**SUPPLEMENTARY INFORMATION****Planning Committee****5 November 2020**

Appendix 1 - Proposed Roundabout Access to Graven Hill and Wretchwick Green, London Road, Bicester

Planning application reference 20/01830/F – Proposed roundabout junction of A41 and Pioneer Road, Bicester – ‘Pioneer Roundabout’

Graven Hill - Pioneer Roundabout

Figure 4: Proposed Dutch Roundabout Design by Bicester Bug

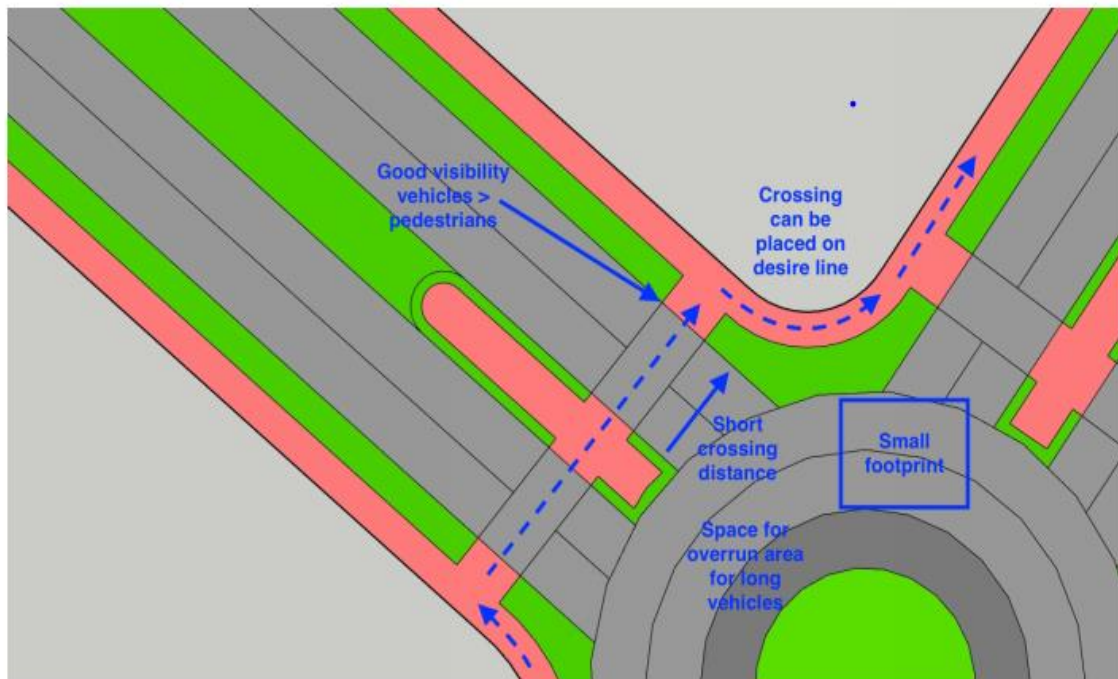
During preapplication discussions, OCC officers asked the designer to investigate the suitability of a Dutch style roundabout on the basis of a sketch provided by Bicester Bike Users Group, and they provided a technical note to OCC at preapp stage. This note is attached as Appendix 2. Note that this did not form part of, and was not referred to, in the planning application, but shows that consideration was given in detail both to safety and capacity issues. From this OCC concluded that there would be both safety and capacity issues that make the Dutch style roundabout unsuitable for this location.

It is worth noting that there has been some confusion over what exactly is meant by a Dutch style roundabout. LTN 1/20 (DfT, 2020b) provides 'a suggested layout for a roundabout with one-way off-carriageway cycle tracks and parallel crossings' (fig 10.37) which I copy below:

This is modelled on Dutch roundabouts in urban areas and features 'parallel crossings, where a zebra crossing (for pedestrians) sits beside a circular, uni-directional cycle track, where cyclists have priority over motor vehicles, which

have to give way to them. We understand that it is this type of crossing that the Bicester Bike Users Group is suggesting at this location.

Just as with a zebra crossing, for it to be safe, the motorist has to be aware of, and slow down for, people at or approaching the crossings who may be about to cross, by bike or on foot. This places the pedestrian or cyclist at considerable risk, both from drivers approaching the roundabout, who will be concentrating on giving way to vehicles from the right, and from drivers leaving the roundabout, who will be concentrating on their exit path. While this might be suitable in a slow speed, urban environment, on an A road approach at the edge of town, OCC officers consider it particularly dangerous and likely to result in death or serious injury.

4.1 A41 Pioneer Roundabout Design

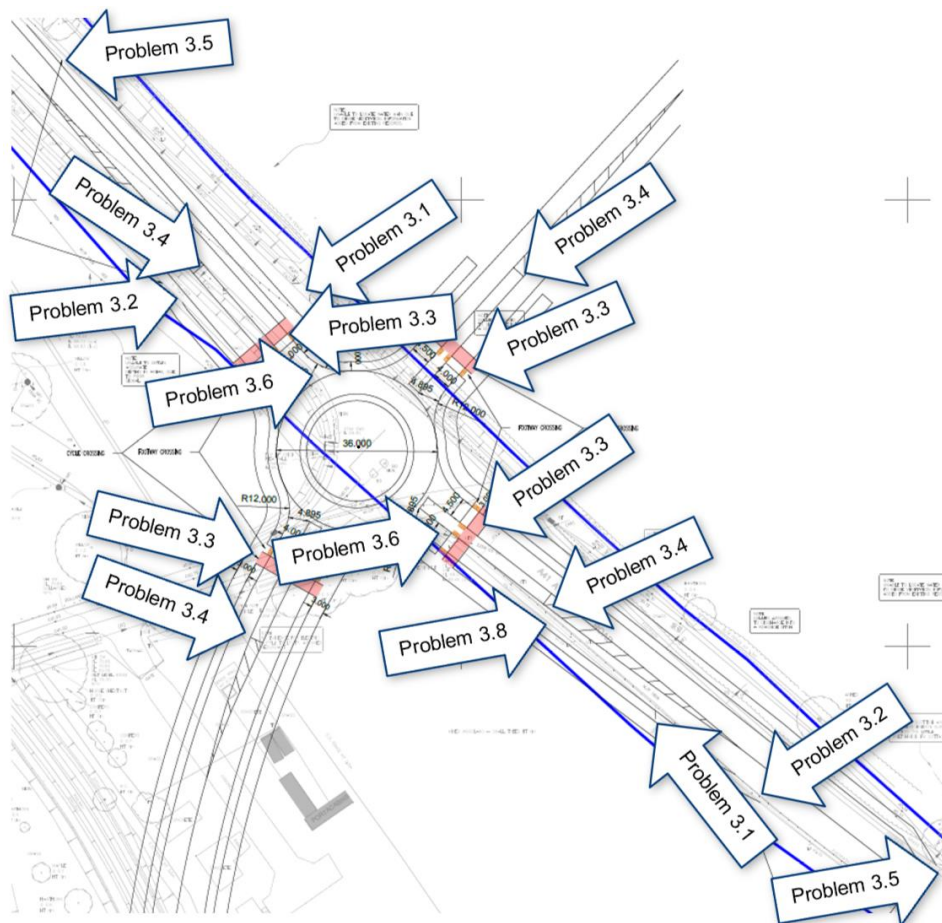
A Stage 1 RSA was initially undertaken in November 2019 on the proposed A41 roundabout. The RSA report and subsequent Designers Response are appended to this Note for information. A subsequent Stage 1 RSA was undertaken in April 2020 on the current junction design. Following the RSA the design has been updated and is shown on Drawing WIE11386-SA-03-026-A02. The changes made to the design reflect the problems identified during the course of the April 2020 Audit, which is also appended to this Note for reference.

The current design shown on Drawing WIE11386-SA-03-026-A02 is considered to be acceptable from a highway safety consideration.

4.3 A41 Pioneer Roundabout Design – Hybrid Dutch Style Two-lane Approach with segregated Cycle Path (controlled)

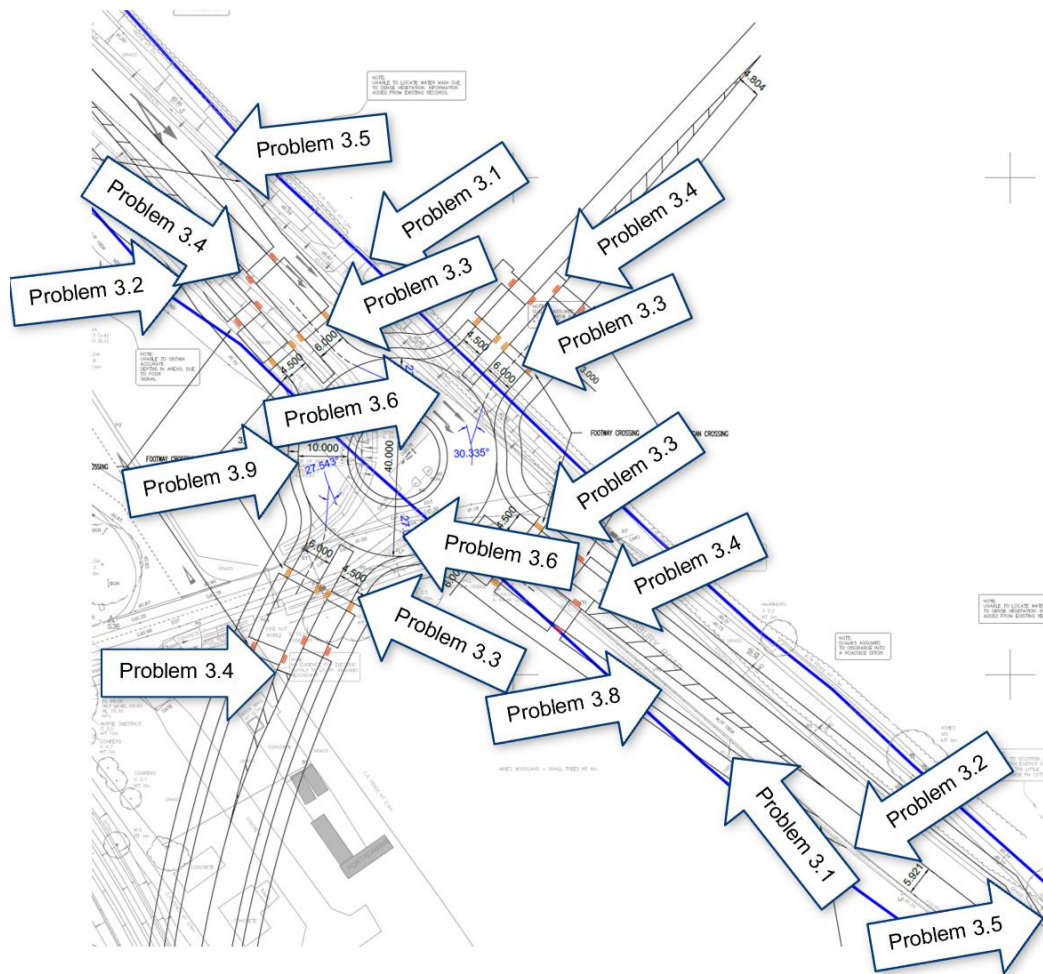
A Stage 1 RSA was undertaken on this roundabout design during May 2020. The RSA report is appended to this Note for information. In total, 9 problems were identified by the Audit Team and these are briefly summarised below and shown on the extract in terms of their locations on the design.

- **Problem 3.1** - Lack of provision of existing access points (field accesses)
- **Problem 3.2** - Narrow footway / cycleway width
- **Problem 3.3** – Uncontrolled crossing provision located near controlled crossings
- **Problem 3.4** – Kerb alignments of the refuge islands
- **Problem 3.5** – Lack of provision for cyclists at the start / end of the footway / cycleway
- **Problem 3.6** – Junction geometry inconsistent with adjacent highway network
- **Problem 3.7** – Vehicle tracking requirements
- **Problem 3.8** – Vehicle collision with kerb or splitter island
- **Problem 3.9** – Concern over the ratio of the entry width to the adjacent circulatory carriageway

Similar to the problems identified for the “Dutch Style” single lane design, of particular note is Problem 3.6 which suggests the design and ethos of this roundabout compared to other nearby junctions could be of safety concern given the nature and speed limit of the A41. The RSA summary highlights that drivers may be caught out by the driving requirements to safely negotiate the proposed layout and this itself could be an inherent safety concern.

4.4 A41 Pioneer Road Roundabout Design – Alternative Geometry with Reduced ICD

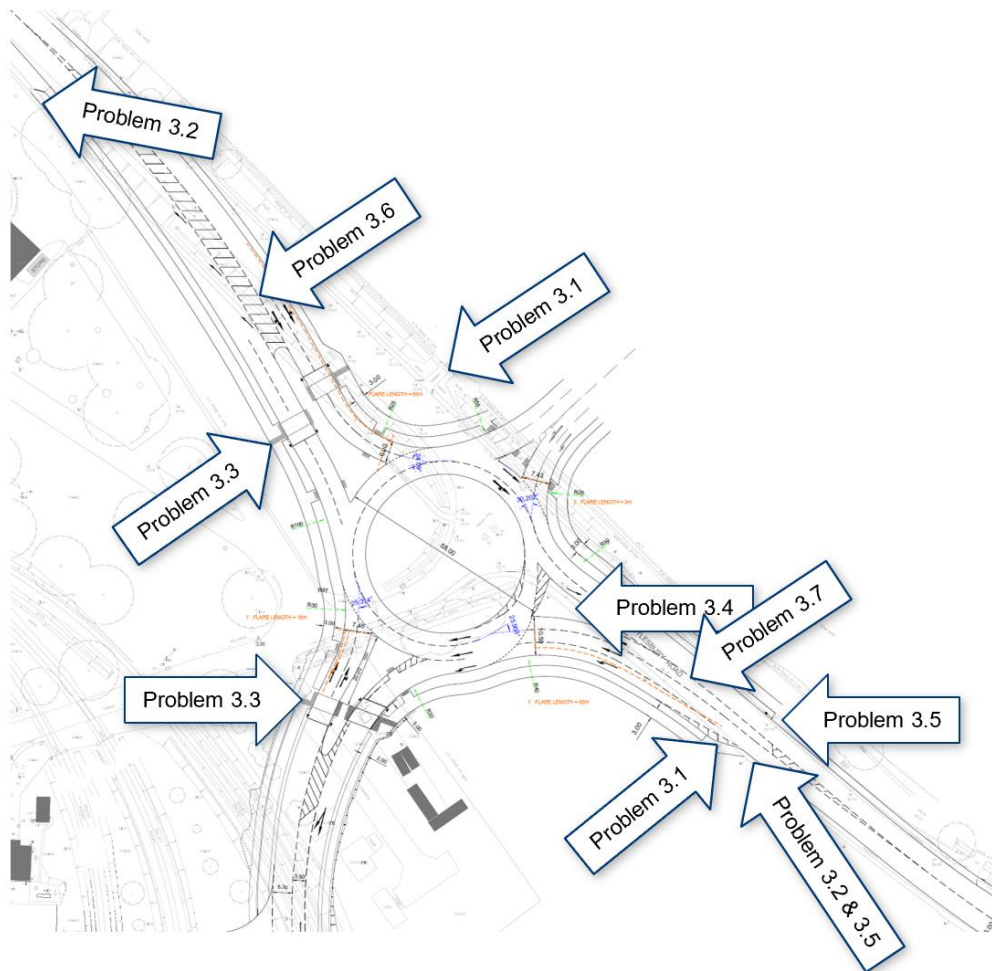
A Stage 1 RSA was undertaken on this roundabout design during June 2020. The RSA report is appended to this Note for information. In total, 7 problems were identified by the Audit Team and these are briefly summarised overleaf and shown on the extract in terms of their locations on the design.

- **Problem 3.1** - Lack of provision of existing field accesses
- **Problem 3.2** - Narrow footway / cycleway width
- **Problem 3.3** – uncontrolled crossing provision located near controlled crossings
- **Problem 3.4** – Lack of provision for pedestrians/cyclists to cross to the east of the roundabout
- **Problem 3.5** – Lack of provision for cyclists at the start / end of the footway / cycleway
- **Problem 3.6** – Insufficient lane width
- **Problem 3.7** – Poor lane marking alignment

A number of the problems identified above are consistent with those for all the designs that have been considered. Further amendments to the design could be undertaken to ensure that the problems identified by the Audit Team are overcome, where these are considered appropriate and necessary.
